Access Compliance Report

Public Rights-of-Way

(Curb Ramps)

Intersection ID: 25272	Main Street: BRIDLE_BROOK_WY	Cross Street: MAYNARD_RD	Location:	N
ADA ID: EDC3AC78CDBF	Ramp Type: PerpDiag	Initial Pass/Fail: Fail	Overall Compliance: No	Severity Score: 10
Codes/Mitigation Info/Possible Solution		Field Measurements/Component Compliance

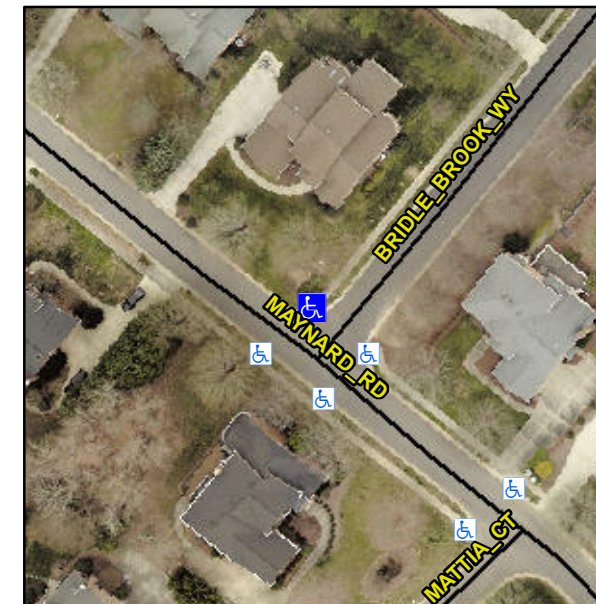
Not Found, R304.5.1, R304.5.3

Compliance	Description	Data	Compliance	Description	Data
N/A	Ramp Length (in)	96.0	Yes	Ramp Slope (%)	6.9
No	Ramp Width (in)	46.0	No	Ramp XSlope (%)	2.5
N/A	Flare Type LT	N/A	N/A	Flare Type RT	N/A
N/A	Flare Slope LT (%)	N/A	N/A	Flare Slope RT (%)	N/A
N/A	Flare Traversable LT?	N/A	N/A	Flare Traversable RT?	N/A
N/A	Landing Length (in)	N/A	N/A	DWS Provided?	N/A
N/A	Landing Width (in)	N/A	N/A	DWS Contrast?	N/A
N/A	Landing Slope (%)	N/A	N/A	DWS Length (in)	N/A
N/A	Landing X Slope (%)	N/A	N/A	DWS Full Width?	N/A
N/A	Landing Curb? (Y/N)	N/A	N/A	DWS Offset (in)	N/A
N/A	Shared Landing?	N/A			
N/A	Gutter Ponding?	N/A	N/A	Gutter Slope (%)	N/A
N/A	Gutter Lip Ht (in)	N/A	N/A	Gutter X Slope (%)	N/A
N/A	Painted X Walk1?	No	N/A	Painted X Walk2?	No
	X Walk 1 Direction	To SW		X Walk 2 Direction	To SE
N/A	X Walk 1 Width (in)	N/A	N/A	X Walk 2 Width (in)	N/A
	X Walk 1 Slope (%)	6.3		X Walk 2 Slope (%)	8.8
	X Walk 1 X Slope (%)	7.7		X Walk 2 X Slope (%)	1.8

Remove & Replace Curb Ramp With Two New Directional Ramps or Equivalent.
